In order that we may complete our review of Westinghouse Electric Corporation topical report WCAP-7832 (Non-proprietary) entitled "Evaluation of Steam Generator Tube, Tube Sheet and Divider Plate Under Combined LOCA Plus SSE Conditions," additional information is required. Enclosure 1 identifies the required information.

EVALUATION OF STEAM GENERATOR TUBE, TUBE SHEET AND DIVIDER PLATE
UNDER COMBINED LOCA PLUS SEE CONDITIONS

This WCAP presents an analysis of the Steam Generator structural integrity, as designed, to demonstrate its capability to withstand the combined stresses of a LOCA and a SSE. Detailed discussion of various off-design situations and other accidents are not considered germane to that purpose. However, for additional clarification, responses to questions 2Ac, 2Ad, 2Ba, 2Bb, and 2Bc have been provided.

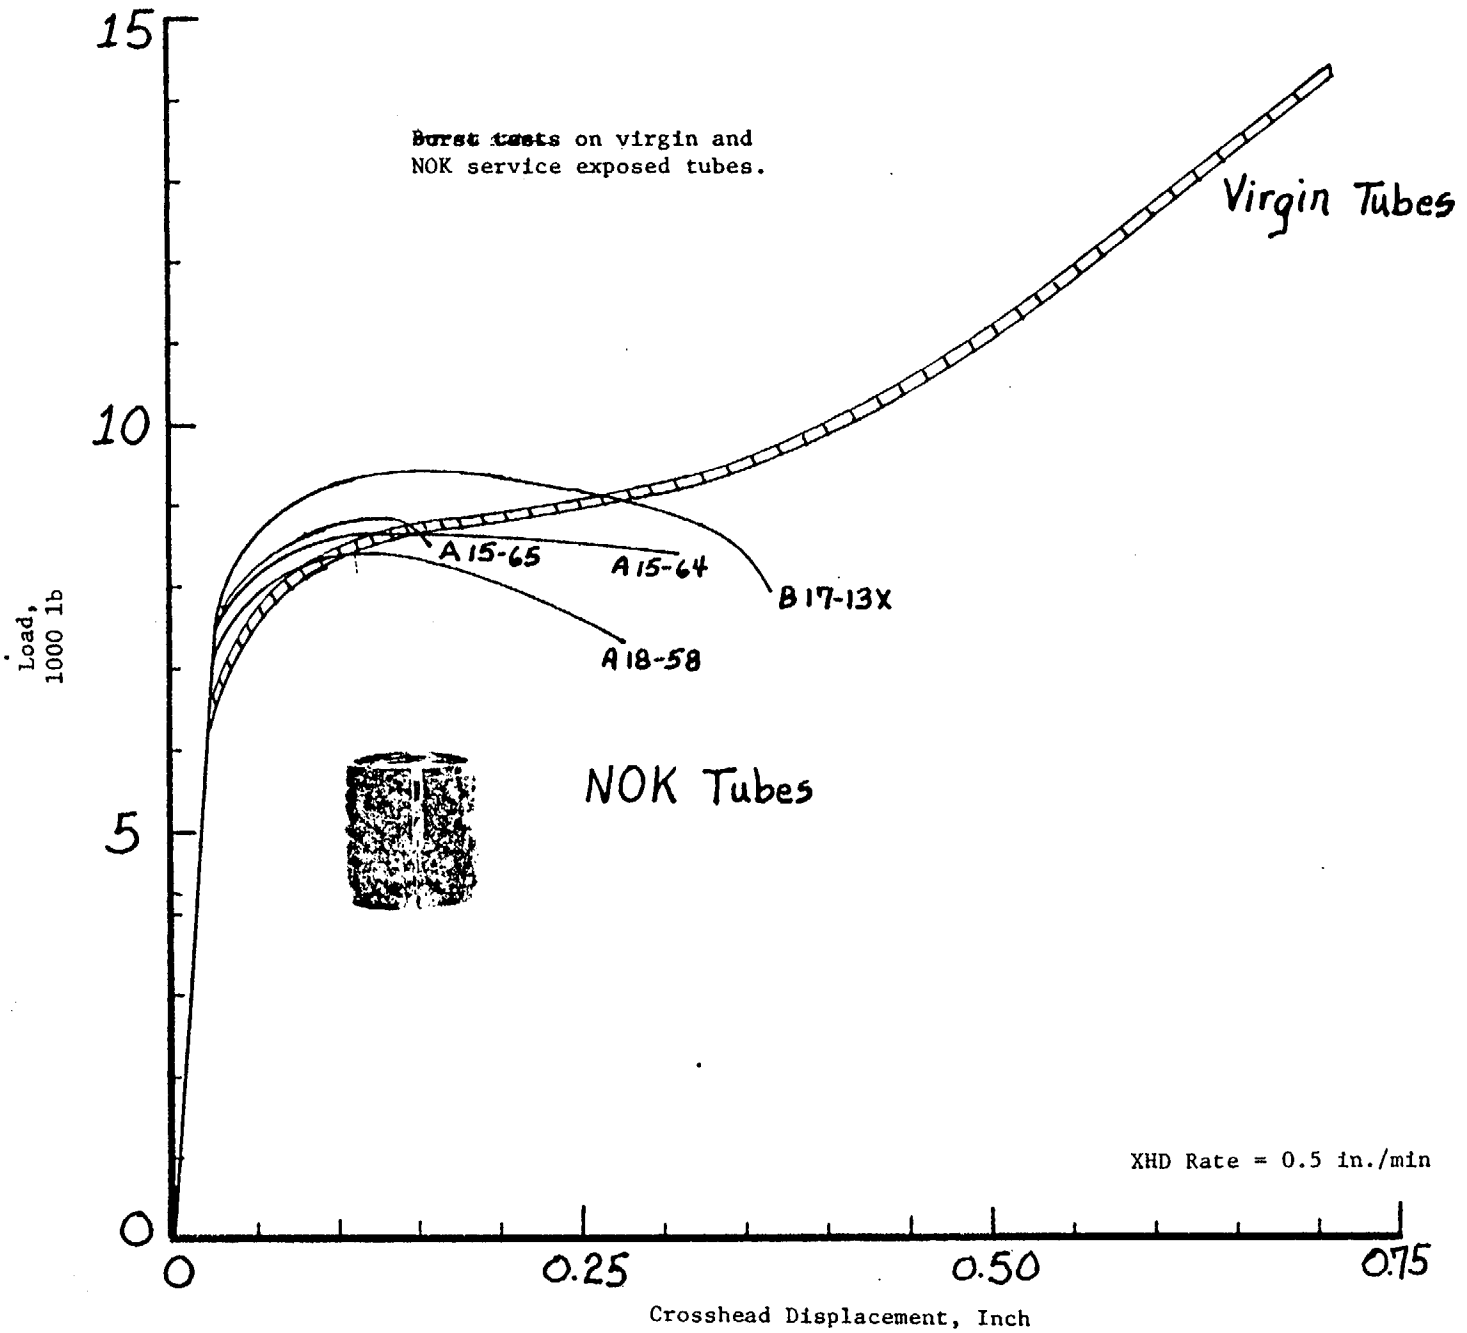
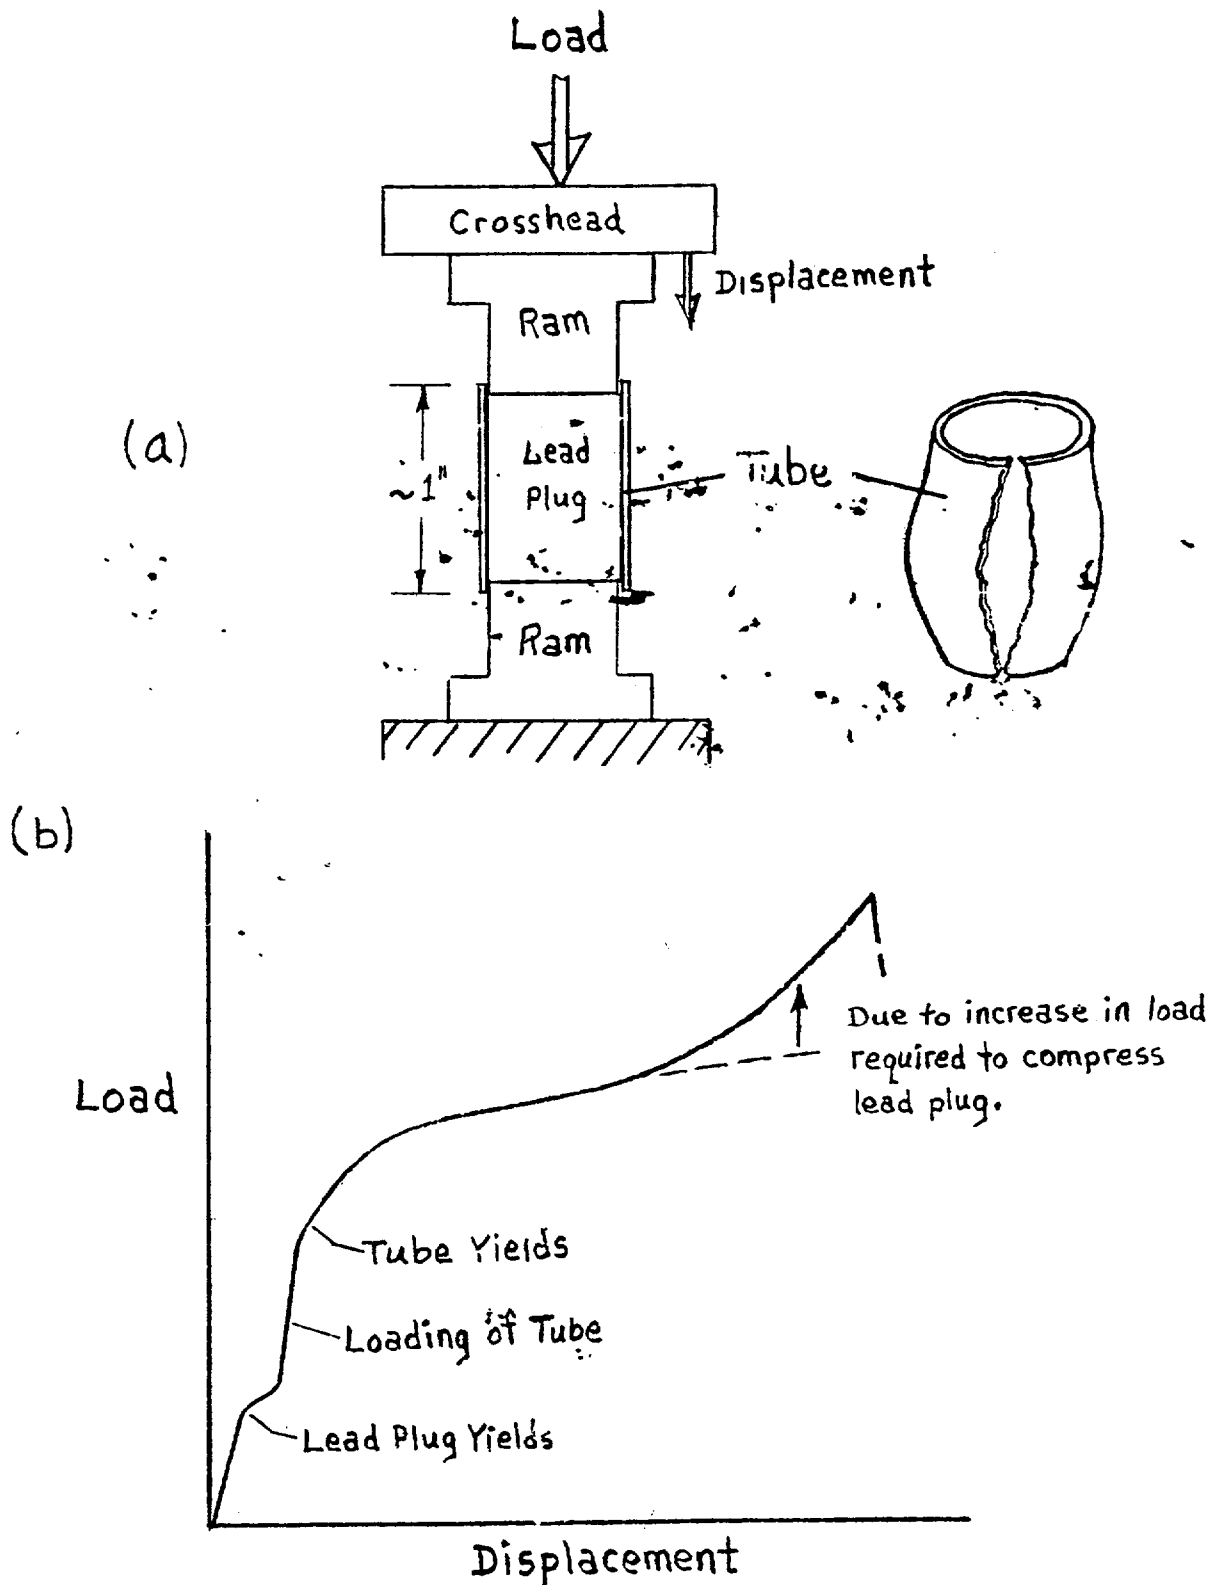
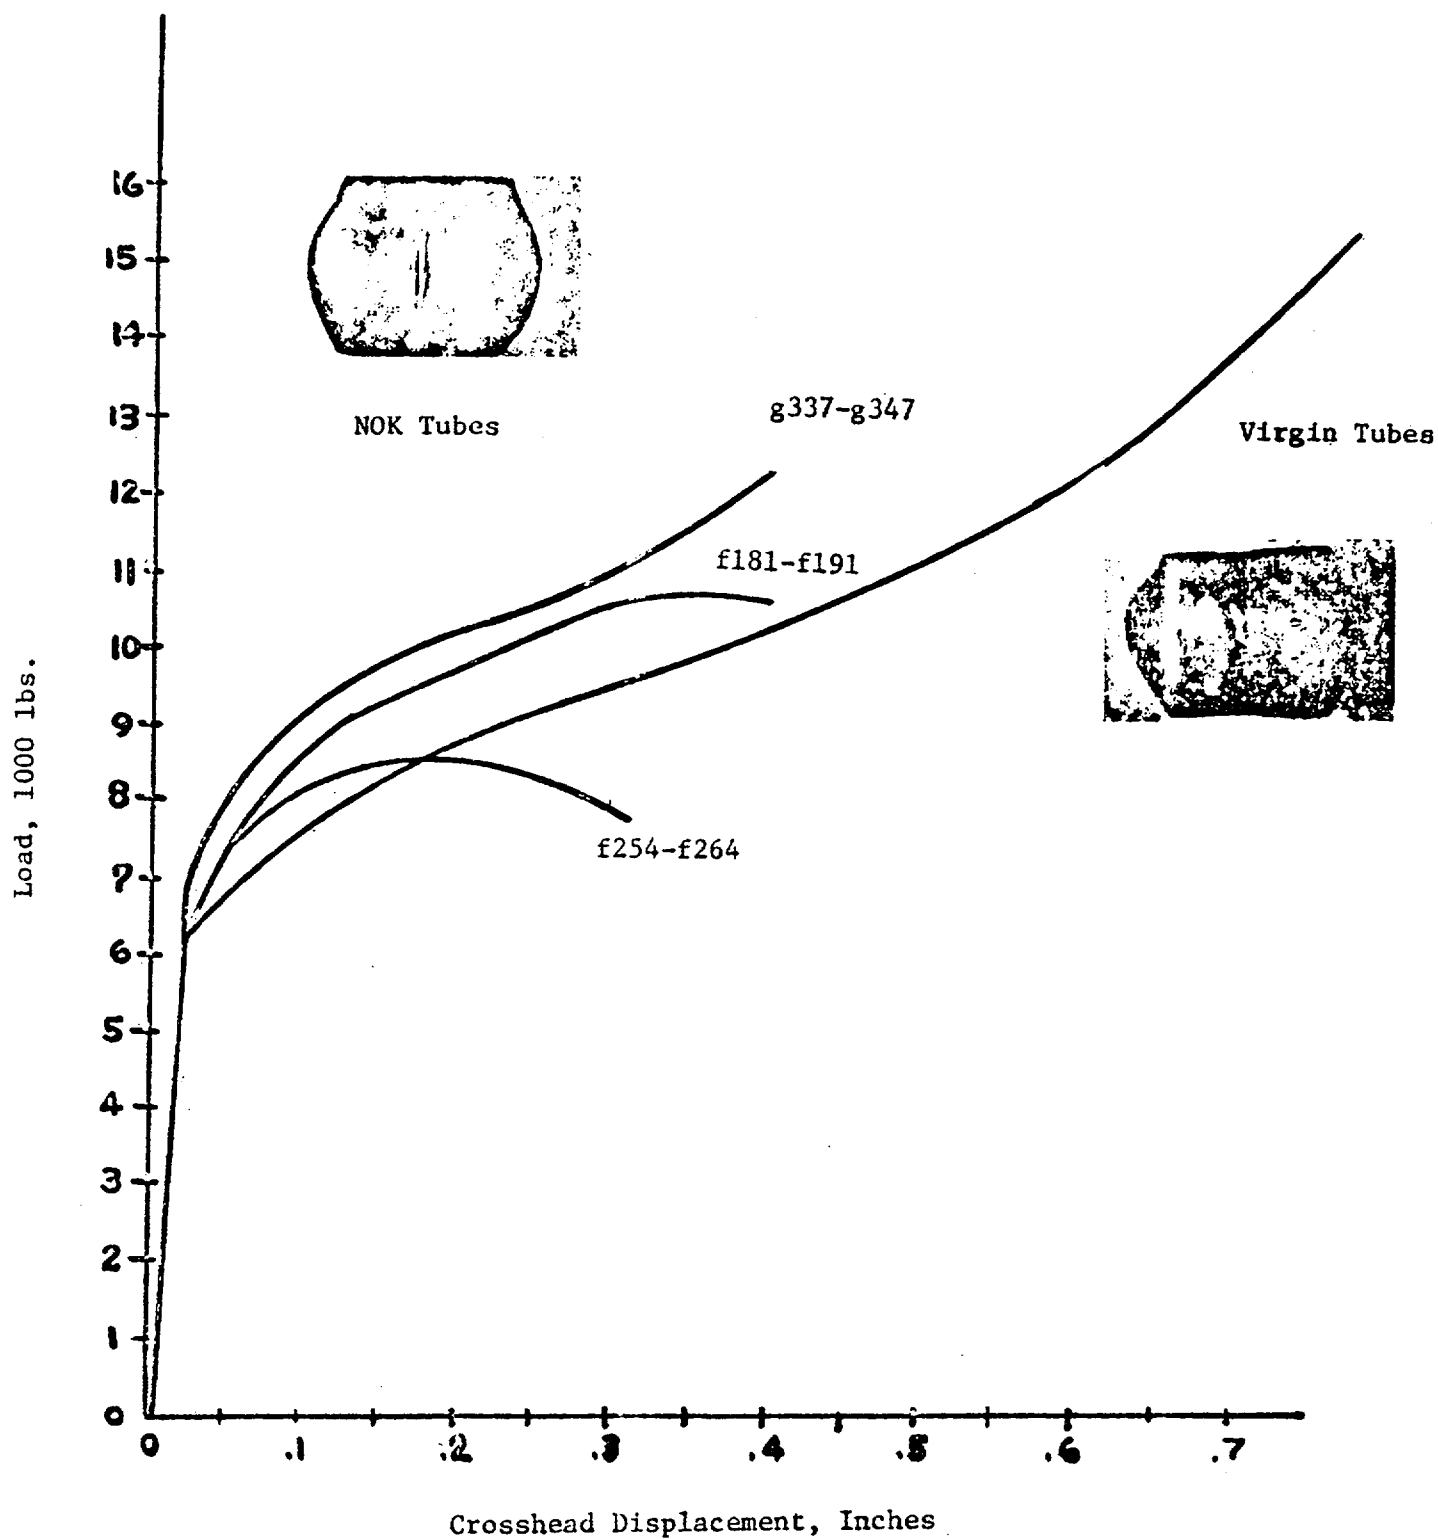
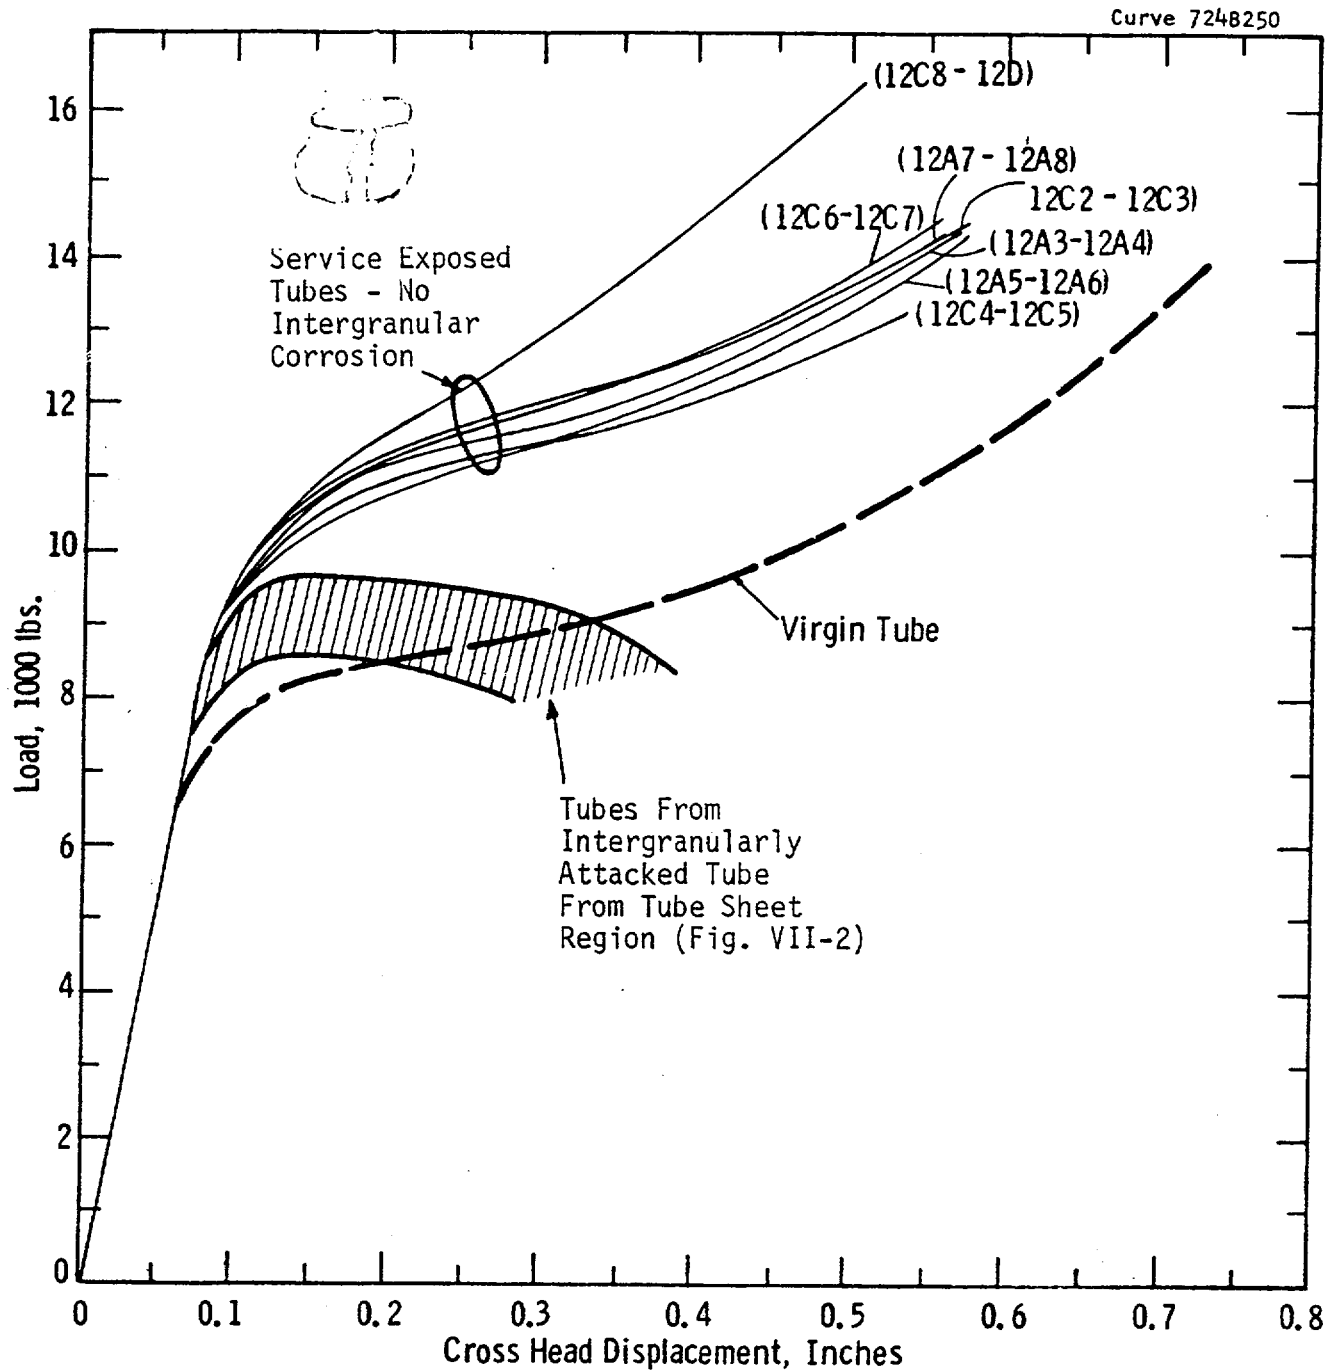
Question 2.B.d.: Identify the method by which corrosion phenomena were considered in assessing the fatigue strength of the tubes.

Reply 2.B.d.: WCAP 7832 deals with combined LOCA plus SSE loading conditions. Since these conditions are classified as Faulted (one occurrence), a fatigue analysis is not required by the ASME Boiler and Pressure-Vessel Code, Section III.

For comparison, the same tests were run on virgin tubes. The test results for virgin tubes were quite reproducible. The results for the tubes with service exhibited some variations which are attributed to variations in the extent of intergranular cracking on the OD surface. Test results are shown in Figure VII-5 attached. Internal pressure was applied through a lead plug (Figure VII-1). Failure of the tubes in Figure VII-5 was by a ductile shear mode, the same as with the virgin tubes. There was no evidence of intergranular cracking in the Scanning Electron Microscope examination of Figure VII-6. A ductile failure is shown in Figure VII-7.
